# Determination 2023/006

**Regarding the compliance of a bracing design for a single-storey dwelling**

**8 Lovelock Avenue, Rolleston**

**Figure 1: Original bracing plan (not to scale)**

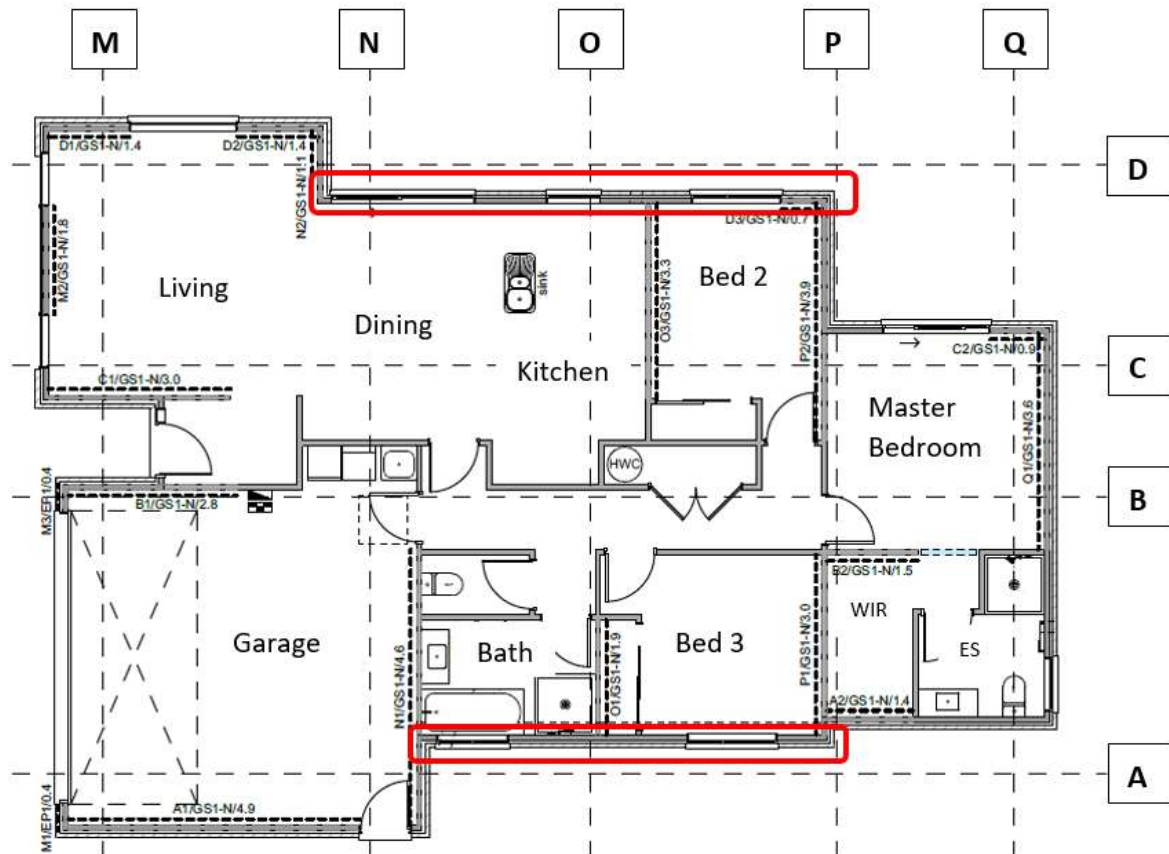
Revised Bracing plan to be supplied demonstrating compliance with NZS:3604:2011 section 5.4.7.2 which states, Each external wall in any storey shall have a total bracing capacity of no less than the greater of that required by section 5.4.7 or 15 Bracing units per metre of external wall length. Specifically considering the external walls along brace line A for the bathroom and bedroom and the wall on brace line D for the Kitchen, dining and bedroom 2.

...the offset between the portions of brace lines D and A are less than 2 metres, so all bits of the wall can contribute to the required total, as the designer has done. There is no need for any revision to the bracing plans.

- 5.9. In this case, the original bracing design relies on the greatest proportion of the bracing elements, and by extension the quantity of bracing units, being located at one end of the building. The bracing elements D1 and D2 in the lounge are on bracing line D, and bracing element A1 in the garage is on bracing line A (refer to Figure 1). There was only one short bracing element (D3) in the corner of bedroom 2, and nothing was specified for the remainder of the external wall for the kitchen and dining area. Further, there was no bracing element included in the external wall for the bathroom and bedroom 3 along bracing line A. For these reasons, I consider the original bracing design did not meet the requirements of paragraph 5.4.3 of the standard because the bracing elements were not evenly distributed along bracing lines A and D.

- 5.22. In this case, the total length or sum of external wall on bracing line A is approximately 16.45m. With 15 bracing units per metre length of wall, a minimum bracing value of 246.75 is required (ie 16.45 x 15). This is the greater of the three criteria, described in paragraph 5.11 above, based on the designer’s bracing calculations provided on plan A2.03. For bracing line A, the designer has calculated that for ‘wind’ loading 438.9 bracing units is achieved, and for ‘earthquake’ loading 376.2 bracing units is achieved. Therefore, the original bracing design did meet the requirements of paragraphs 5.4.7 and 5.4.7.2.

- 5.23. Similarly, the total length or sum of external wall on bracing line D is approximately 13.08m. With 15 bracing units per metre length of wall, a minimum bracing value of 196.2 is required (ie 13.08 x 15). Again, this is the greater of the three criteria, described in paragraph 5.11 above, based on the designer’s bracing calculations provided on plan A2.03. For bracing line D, the designer has calculated that for ‘wind’ loading 222.8 bracing units is achieved, and for ‘earthquake’ loading 199.1 bracing units is achieved. Therefore, the original bracing design did meet the requirements of paragraphs 5.4.7 and 5.4.7.2.

- 5.25. Accordingly, I conclude the original bracing design did not comply with the means of compliance stated in the building consent application for clause B1.

- 6.1. In accordance with section 188 of the Building Act 2004, I determine that the original bracing design for building consent 212950 did not comply with Building Code clause B1 Structure by way of NZS 3604:2011.
